## ORIGINATION FORM

Proposed Revisions to a Standard Plans Index  
(Please provide all information — Incomplete forms will be returned)

Index Number: 102-607  
Sheet Number (s): 1  
Index Title: Two-Lane, Two-Way, Mobile Operation, Work on Shoulder, Work Within the Travel Way

**WORK ON SHOULDER**

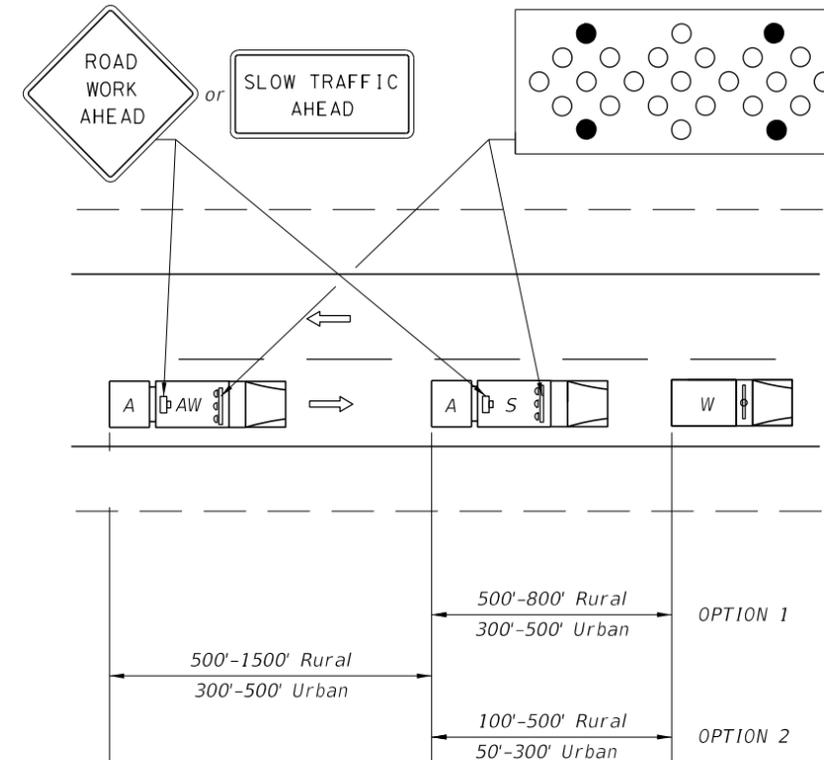
**OPTION 1:** Advanced Warning Vehicle is optional and to be operated on the shoulder when feasible. If an Advance Warning Vehicle is operated in the shoulder, an approved Truck Mounted Attenuator is required on both the Advance Warning and Shadow Vehicles. If an Advance Warning Vehicle is operated in the lane behind the Shadow Vehicle, an approved Truck Mounted Attenuator will be required on the Advance Warning Vehicle, but not required on the Shadow Vehicle. The Advance Warning Arrow Board and Warning Sign is required on both the Advance warning and Shadow Vehicles.

**OPTION 2:** Advanced Warning Vehicle is required and must be operated in the lane behind the shadow vehicle. An approved Truck Mounted Attenuator will be required on the Advanced Warning Vehicle but not required on the Shadow Vehicle. The Advance Warning Arrow Board and Warning Sign is required on both the Advance Warning and Shadow Vehicles.

REVISED DETAIL - CONSOLIDATED WITH 102-619

**WORK IN TRAVEL WAY**  
(Option 2 Shown, Option 1 Similar)

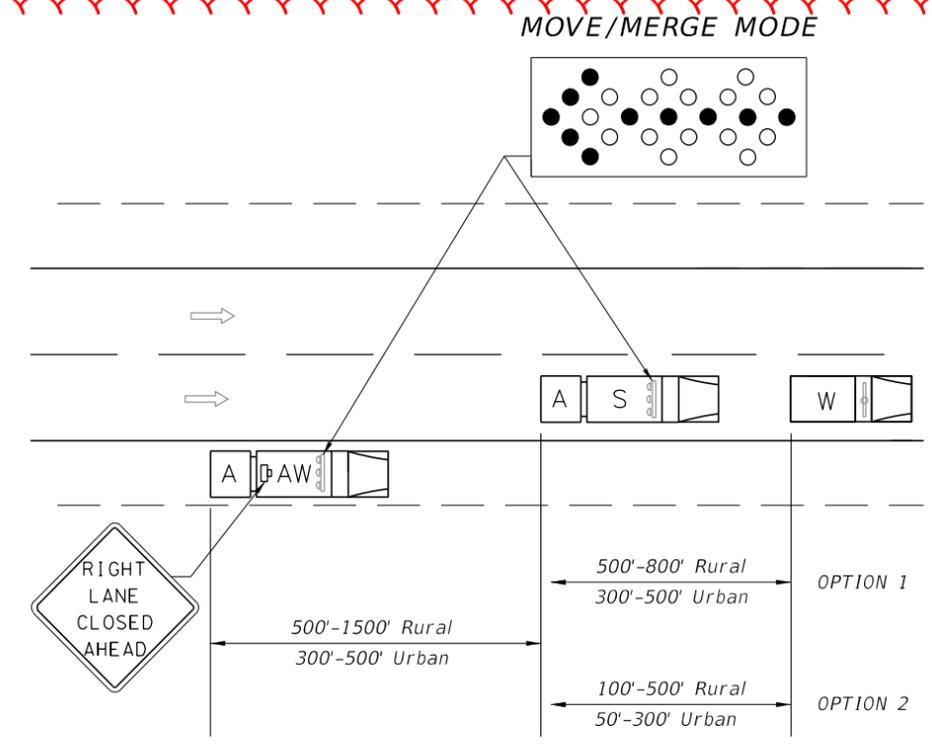
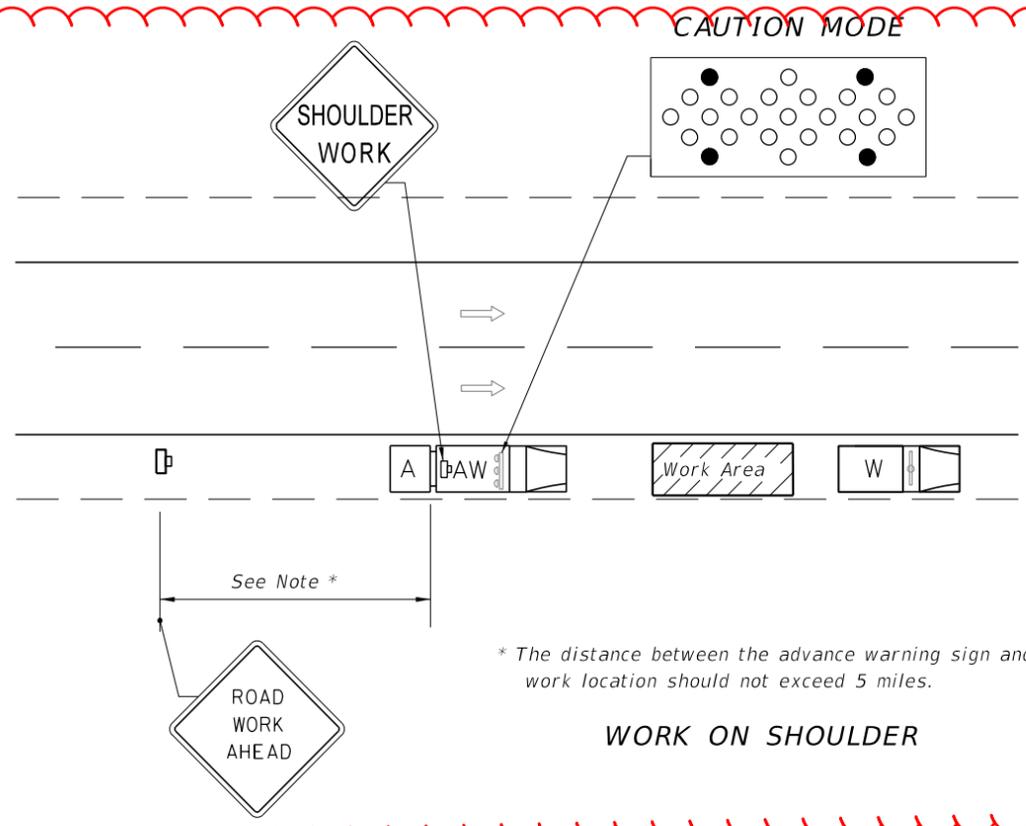
REVISED NOTES

REVISED DETAIL - CONSOLIDATED WITH 102-619

RENAMED "MOBILE OPERATIONS"

OPTION 1: Advanced Warning Vehicle may be operated in the lane behind the Shadow Vehicle where adequate shoulder width is not available. Approved Truck Mounted Attenuators are required on both the Advance Warning Vehicle and the Shadow Vehicle.

OPTION 2: Advance Warning Vehicle must be operated in the lane behind the Shadow Vehicle. Approved Truck Mounted Attenuators are required on both the Advance Warning Vehicle and the Shadow Vehicle.

INDEX  
102-619

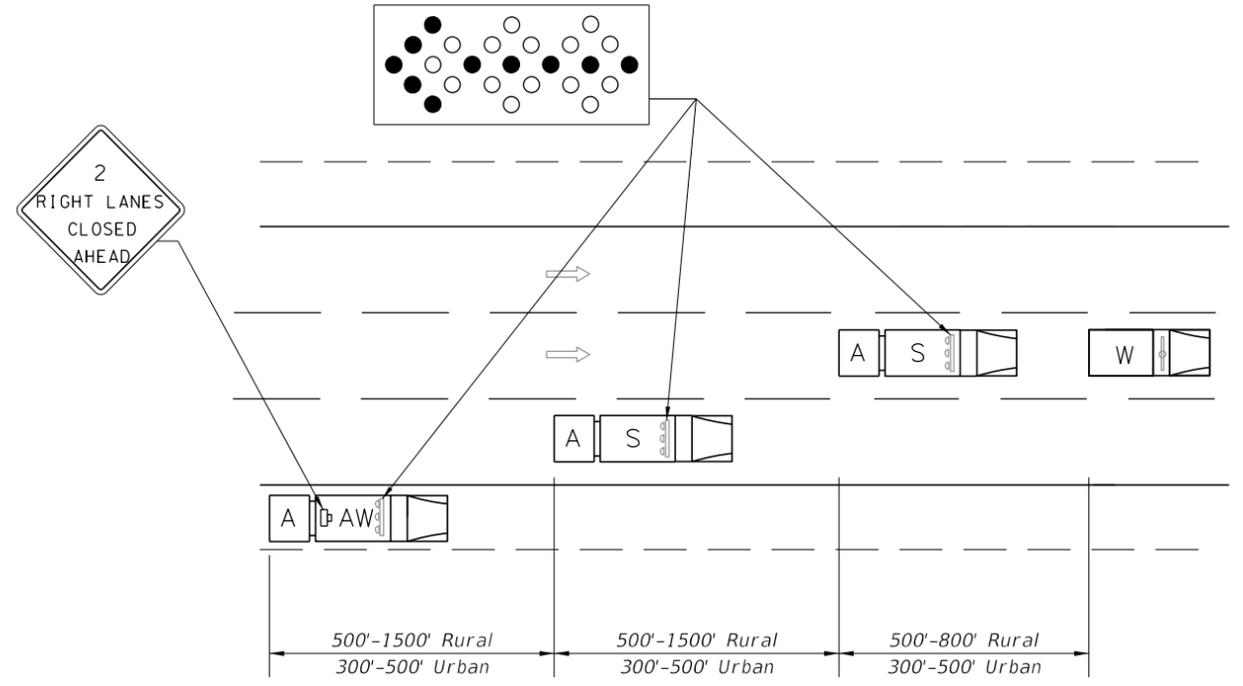
UPDATED DETAIL

DELETED DETAILS  
- CONSOLIDATED  
WITH 102-607  
SHEET 1 DETAILS

CONSOLIDATED  
WITH 102-607 AND  
MOVED TO SHEET 1

INDEX  
102-619

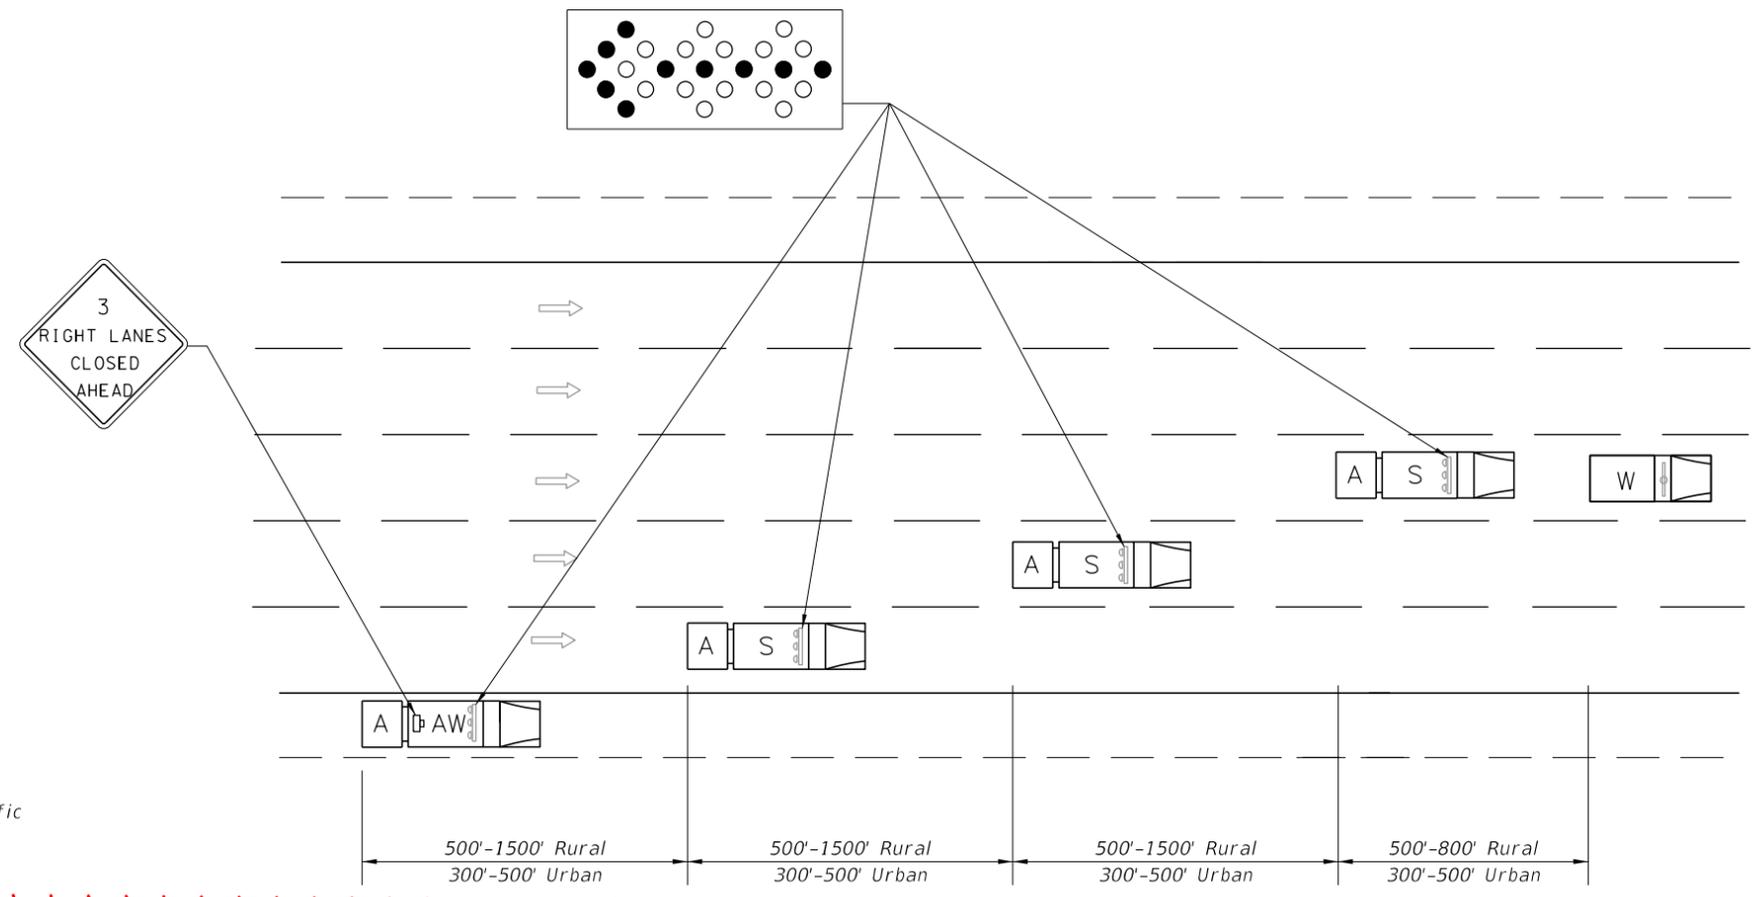
DELETED SHEET - REVISED DETAILS AND MOVED TO SHEET 2

WORK WITHIN TRAVEL WAY, CENTER LANE OR OUTSIDE CENTERLINE  
Where adequate shoulder width is not available, the advance warning vehicle may drive in the lane.
